14-26 COMMERCIAL ROAD KINGSGROVE REVIEW OF NEW M5 PROJECT ENVIRONMENTAL IMPACT ASSESSMENT (EIS)

REVIEW OF WESTCONNEX M5 STAGE 2 PROJECT INFORMATION AND EIS

Figure 10 – Impact of project on flooding (100 year ARI)

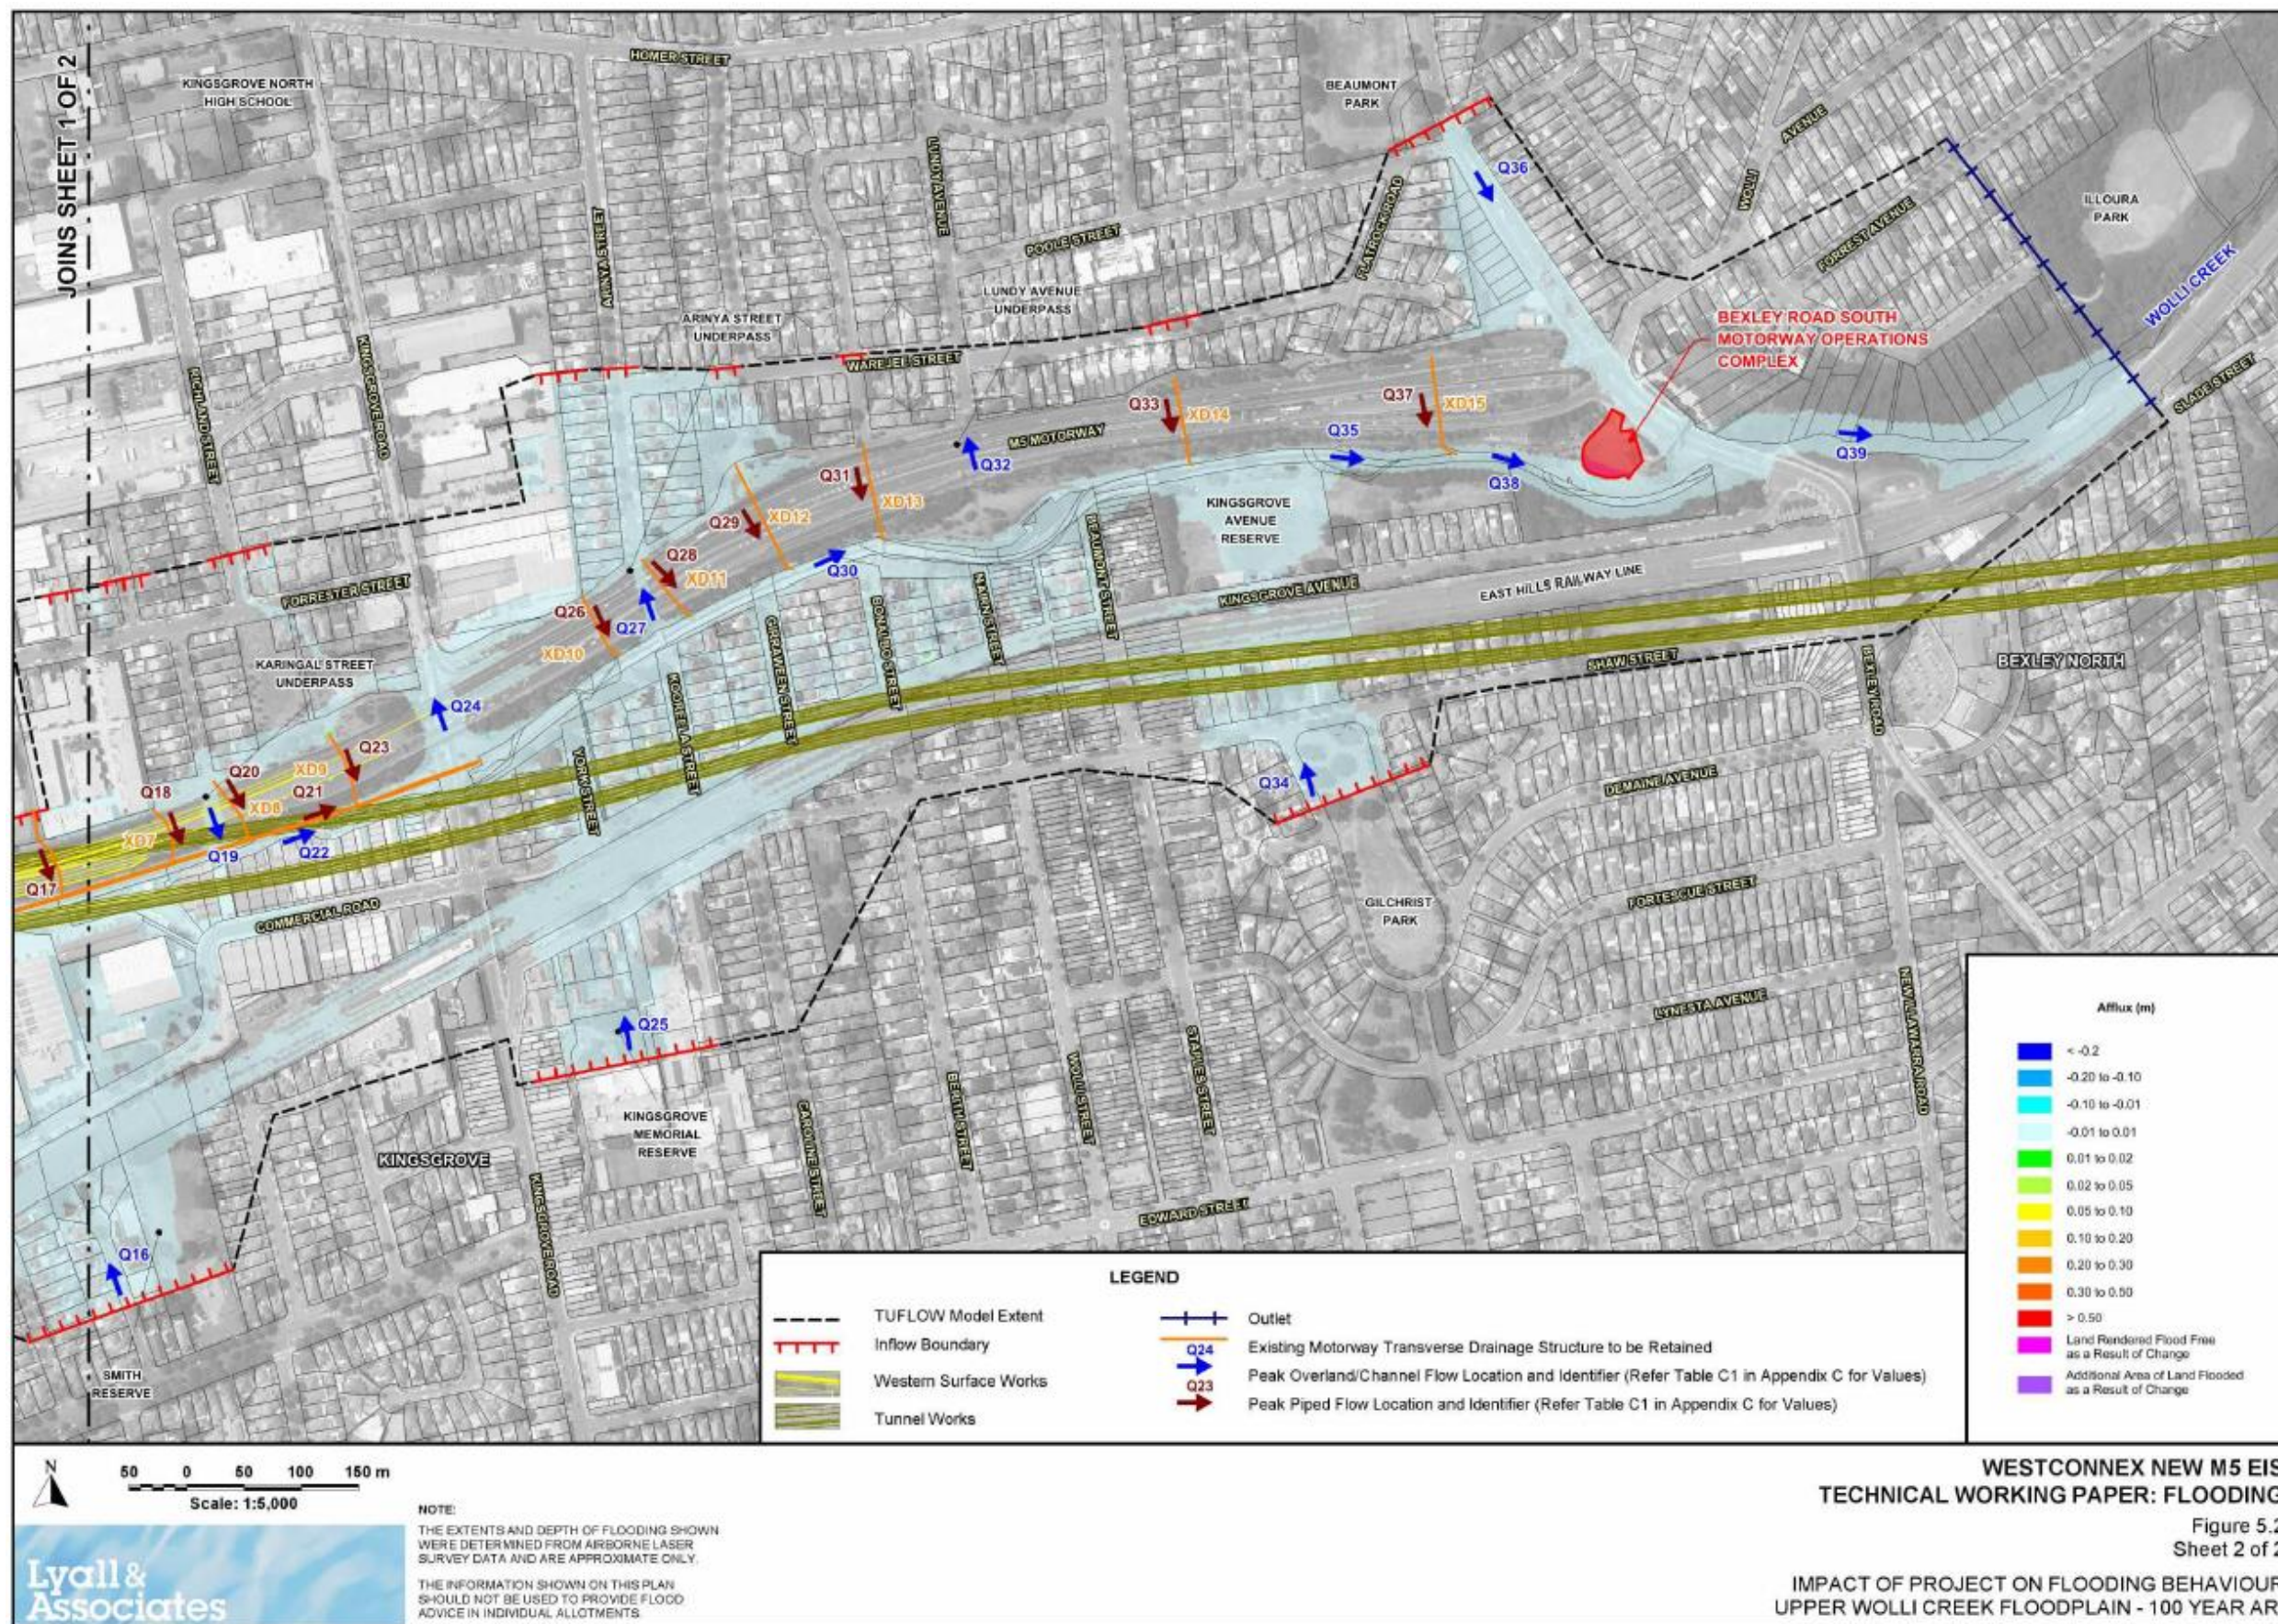
there will be minimal impact of flooding at the site with an afflux (increase in water level) of -0.1 to 0.01m variance as shown in Figure 10.
